*Proceedings of the Madras Government, Public Works Department,
17th September 1866.*

No. 422. Read the following letter from the Consulting Engineer for Irrigation and Canal Company, to the Secretary to Government, Public Works Department, dated Anantapore, 27th August 1866, No. 54 :—

1. I have the honor to submit, for the consideration of Government, the correspondences as per margin,* on the subject of a modification of the arrangements of the towing path of the Hindry aqueduct.

Hindry aqueduct Railings.

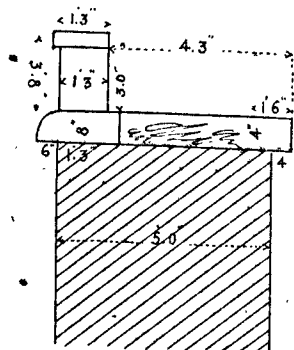
1. Will you kindly inform me whether these have been procured by indent from Home.
2. If not yet purchased, I propose to substitute a masonry parapet, which will, I think, be more in keeping with the massive stone aqueduct.

3. The shaded portion shows the present work, and the rest the form in which I would finish it off. For one bullock a path of four feet three inches with a solid parapet would be more convenient than six feet with a railing, I believe. For men the same. Two bullocks could scarcely pass in either case. In case you have to refer home, perhaps it would be well to ascertain the views of the Consulting Engineer. The parapet might be open work, if wished.

1. In reply to your letter No. 74, of the 20th instant, I have the honor to inform you that I see no objection to the substitution of a masonry parapet for an iron railing at the Hindry aqueduct, provided it be quite clear that the railings have not already been purchased. I observe that the estimate in which these railings are included was sanctioned in 1862.

2. Should a parapet be adopted, I would recommend that its height above the towing path be not less than three and a half feet, and the details should be in keeping with a work of the size of the aqueduct. A string course eight inches deep with a six-inch projection on such a large work would not, I think, have a good effect.

Hindry Aqueduct tow path.

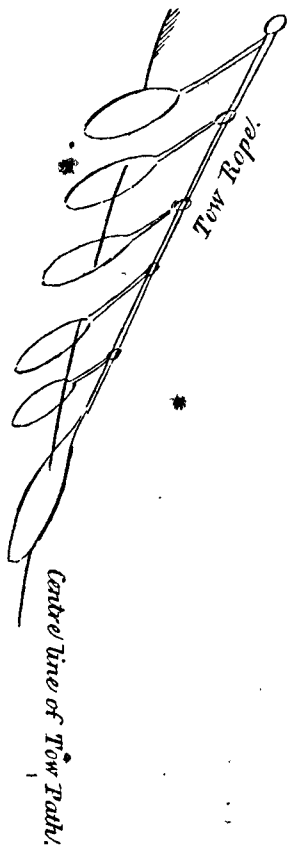
1. I have the honor to acknowledge receipt of Captain Mullins' letter No. 96 of 3rd instant, with your foot Note No. 216 of 7th instant. I enclose a sketch of the original design with iron railings compared with the one I proposed* with as parapet. I only make out 6 feet 6 inches as the original design on the inner and outer side of centre line of railing. My letter No. 149 of 15th June was written on the supposition of the inner coping being corbelled out six inches. If that were done, as it might safely be (see dotted lines in figure 2), a width of 4 feet 3 inches at the ground, and 4 feet 6 inches for practical purposes would be obtained. If more than this were wanted, the parapet might be moved out to the position cross hatched with dotted lines in Fig. 2, and 5 feet towing path secured.

2. I imagine that if six men (say) tow a boat they have a tow rope looped into six loops, or loops on cords fixed to a stopper on the rope, thus (see margin), and put the loops each man one across his chest over his shoulders, as on the Pulicat canal; on that canal the track of the men is no broader than a village foot path, worn by single passenger; I think, then, that it would not be well to corbel out the parapet, and so make it far less secure, for the sake of six inches of tow room, but the inside might be well corbelled out 6 inches.

3. Happiness in structure may often lie in the violation of symmetry (or monotony) wherever a reason for so doing is apparent. In the case of the aqueduct, one arch spans a raised main road, and an observer would at once look to see what special provision had been made for the road; and if none, would think that often the aqueduct were made it had been found convenient to mar one of the arches by taking a road through it. If he saw some extra moulding over that arch, and especially a heavy cornice and parapet apparently calculated to protect the road from bodies falling over from the tow path side, I think he might approve it. No Cathedral in England, except Saint Paul's at Salisbury, is without great "variation in style"—(Captain Mullin's paragraph 5.)

4. I confess that I completed the corbelling over the whole arch because it was cheaper to do so than to pull the old part down; and possible to take down the corbels, if not approved, but not possible to build any easily if required. I have no preference either way, and if Captain Mullins, on inspection, does not think the argument for and against its style as equally balanced as I do, I will willingly remove the corbelling over the road arch.

The Government sanction the substitution of a masonry parapet for iron railings provided in the estimate for the Hindry aqueduct, and the adoption of such a design as will afford a towing path not less than 4 feet 3 inches in width.
